Hornsby Ku-ring-gai Hospital State Significant Development Response to Submissions

Stage 1 Redevelopment

Submitted to Department of Planning & Infrastructure
On Behalf of NSW Health Infrastructure

April 2013 ■ 12290

Figure 1 - Car Parking Provision On-site

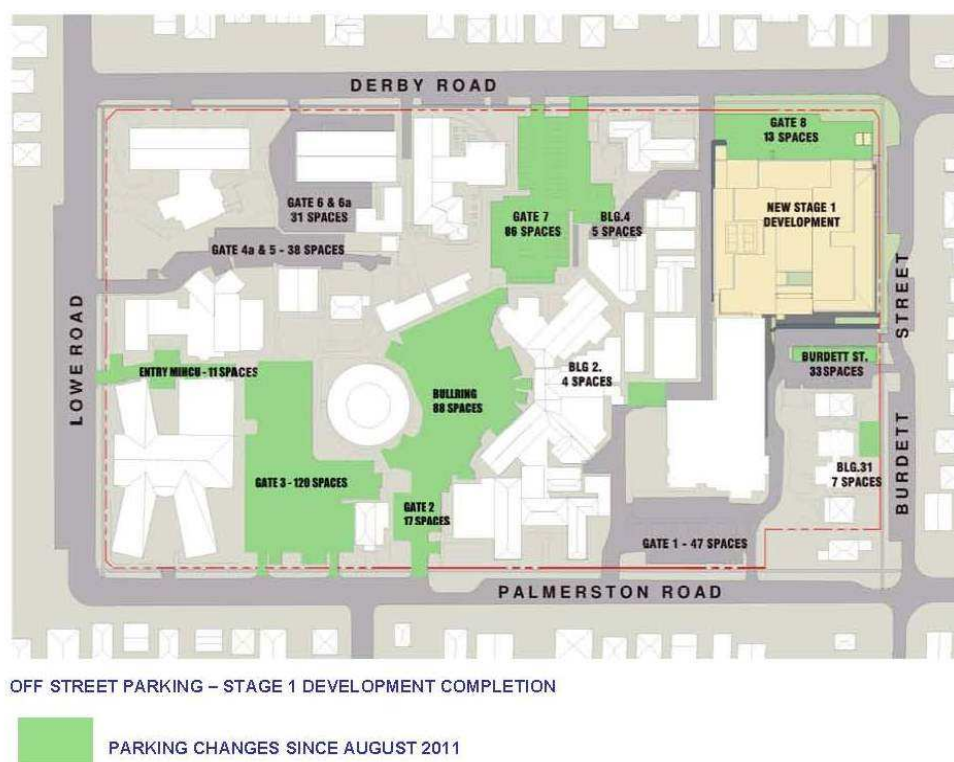
Accordingly, the Department requests clarification of car parking matters including a specific car parking breakdown addressing the following:

- *Original on-site car parking provision (total supply of on-site car parking before the development of the Mental Health Facility)*
- *Mental Health Facility car parking provision (total supply of on-site car parking when the Mental Health Facility is completed)*
- *Stage 1 redevelopment car parking provision (total supply of on-site car parking when Stage 1 is completed, including a breakdown of the car parking provided under the subject SSD application, and any additional car parking undertaken under the Infrastructure SEPP.*

Note: This must also identify where the 25 car parking spaces approved in the south-east corner of the hospital campus for the Mental Health Facility will be relocated, and under which approval. Also, on-street parking is not for the exclusive use of hospital staff or visitors and as such cannot be relied upon to meet on-site car parking.

Additionally, following completion of the Stage 1 development, the total demand for car parking across the hospital campus will be 770 spaces, whilst the supply of on-site car parking would appear to be only 495 spaces. Further clarification on how the existing and future shortfall in car parking supply will be alleviated as part of the hospital's ongoing redevelopment, including as part of the Stage 1 works.

A Traffic and Parking letter has been prepared by TTW to address the issues raised in the submissions (see **Appendix C**). To address the above Department raised matter, a breakdown of the existing car parking, mental health parking and the Stage 1 car parking is provided in **Table 1** and as represented by **Figure 1**.

Table 1 demonstrates that the net gain of car parking spaces on Campus after the completion of all current known construction activities (estimated for completion in 2015) is 159 spaces, resulting in an overall number total of 500 car parking spaces on the Hospital campus.

At present the Campus accommodates 341 spaces. With 50 spaces added following the completion of the Mental Health this will rise to 391. Car parking provided at the Bullring Car Park by using Exempt Development provisions under the *State Environmental Planning Policy Infrastructure 2007* (ISEPP) has further increased this to 453 spaces on-Campus.

The Stage 1 Redevelopment will provide parking as required to meet demand. The demand outlined in the Traffic and Parking Report appended to the EIS is **100** spaces. The Stage 1 Redevelopment will provide a total of 109 spaces (9 spaces in surplus of the demand for 100 spaces) through a combination of the 62 spaces provided at the Bullring and a net gain of 47 in the footprint of the Stage 1 Redevelopment area. The overall net increase in parking on site which includes work undertaken separate to the Development Application is 159 spaces. This includes the 25 spaces for the Mental Health facility which have been relocated to the Bullring Car Park before Mental Health has completed construction.

Figure 2 – Building Setback

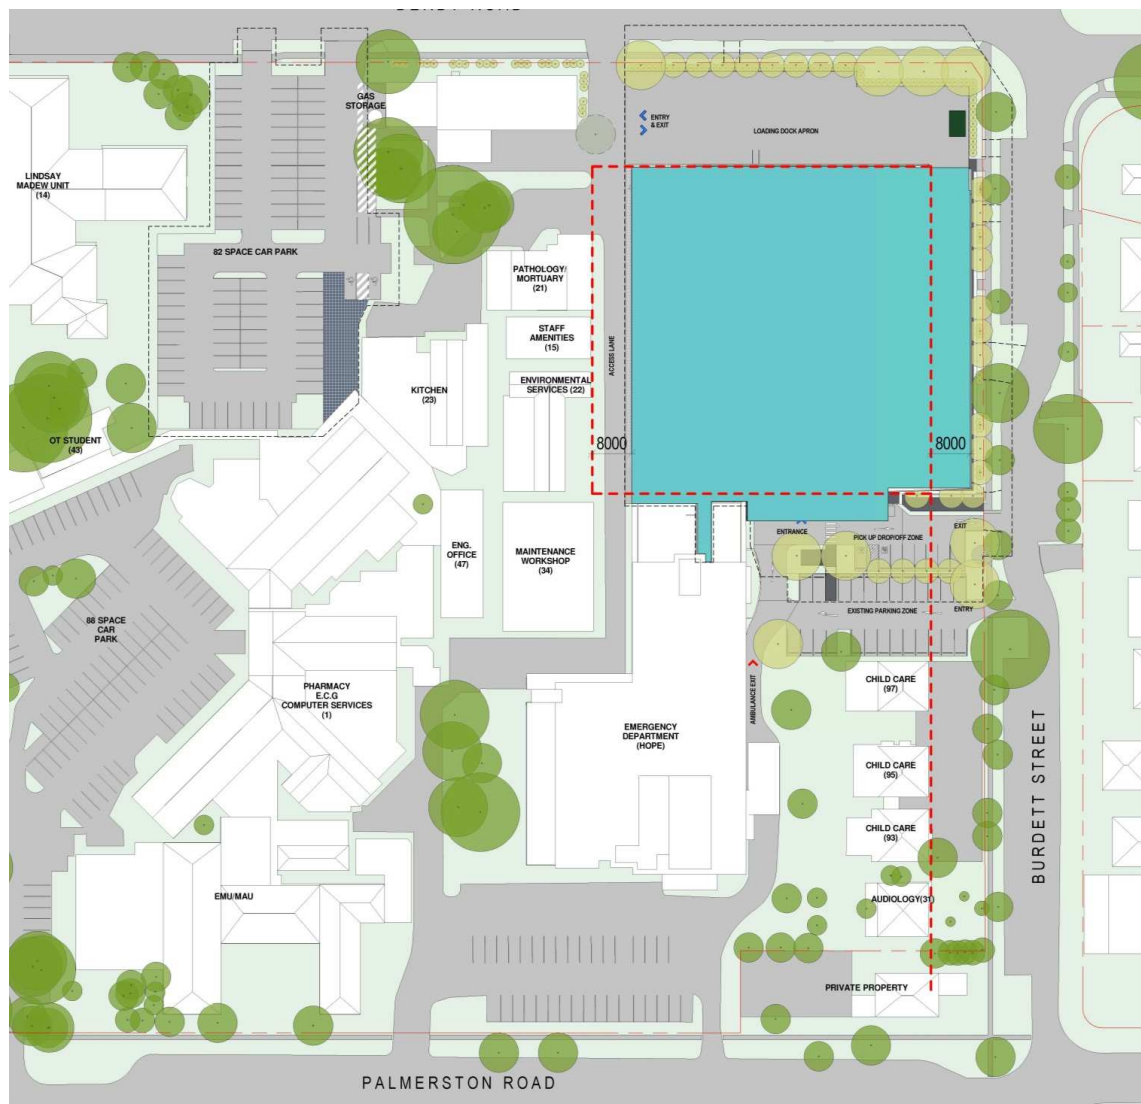
However, the setback of the proposed building is only 2.7m from the southern boundary (Burdett Street), and the height of the building in this location is between 13 to 14 m above existing ground level, which is significantly higher than existing residential development opposite the site. Whilst the department acknowledges the design evolution and measures included to minimise visual impacts of the building (outlined above), the current southern setback of 2.7 m does not facilitate an adequate deep soil zone to allow vegetation of an appropriate size to exist and provide appropriate screening of a building of this scale. The department therefore requests that a greater setback be provided, along with an increased deep soil zone in collaboration with additional plantings of mature vegetation in this location. Further details of the type and arrangement of vegetation to be used in this location to provide appropriate screening of the Stage 1 building is to be detailed in a separate landscape plan.

The Stage 1 footprint has been located to provide for optimal functional adjacency and connectivity to the HOPE building and to minimise disruption to ongoing hospital-related activities and to provide for the best continuity of services to the community. Its location also allows for only minimal removal of vegetation and takes advantage of existing driveway crossings. Furthermore, and most importantly, the floor plate is designed to deliver optimal functional and efficient health services. There is no flexibility for the building to be moved further north, or for its footprint to be reduced in size to gain a greater setback area along Burdett Street on the southern boundary.

If a dysfunctional footprint size were to be implemented and if no GFA were to be lost, it would result in a taller building (albeit without its desired functional connectivity). **Figure 2** over illustrates that if the building were to be setback 8m to align with the existing childcare centres to the west of the site, the building would obstruct the access laneway to existing hospital facilities and would abut against a number of existing functioning buildings.

By moving the whole building footprint to the north it would require the demolition of substantial occupied amenities to allow construction of Stage 1. These include, environmental services (approximately 375m²) and maintenance workshop (approximately 500m²), and the three-storey Pathology/ Mortuary Building (approximately 860m²) which would impede the function of these hospital uses and require demolition.
